LO Distribution Module Changes

(from Single Pixel test results)

Gary N. Anderson

January 16, 2009

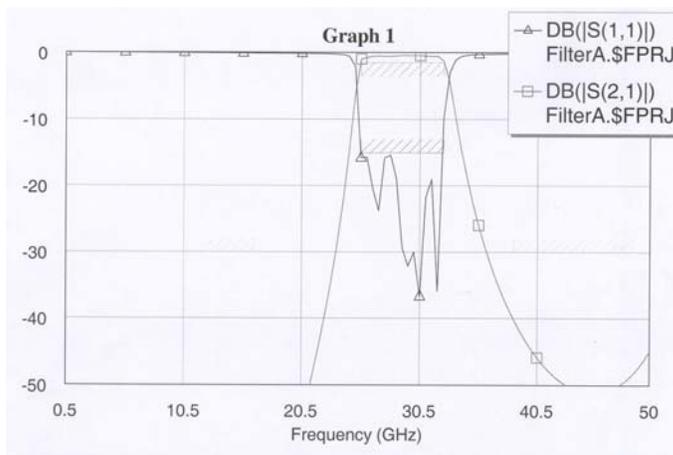
Single-pixel tests were performed using a test fixture consisting of the multiplier and bandpass filter shown in the schematic (LO Distribution Module (High Frequency Side)) above.

Tests showed the following problems:

1. The LO multiplier output dropped off sharply outside the original frequency range.
2. During test, the LO drive desired for the input of the downconverter was significantly higher than called for by the LO1 specification.
3. A spur was detected at the noise floor during a one minute integration. Its frequency indicated that one of the mixing inputs that created it was the LO1 input to the x2 multiplier.

Filter (original)

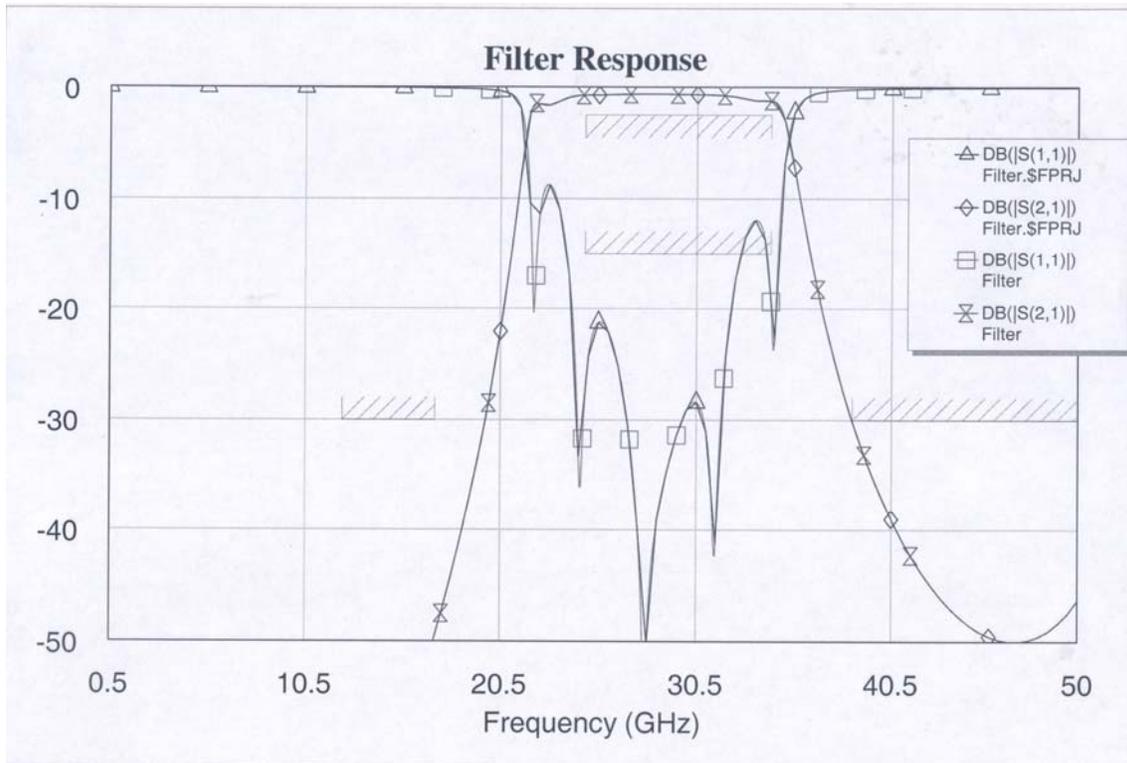
1. The multiplier output filter was originally designed around the initial specification. The original bandwidth was kept as narrow as possible to improve the 3rd harmonic rejection and to give some margin to allow for manufacturing tolerances.

The redesigned filter response is shown below.

Modified Bandpass Filter
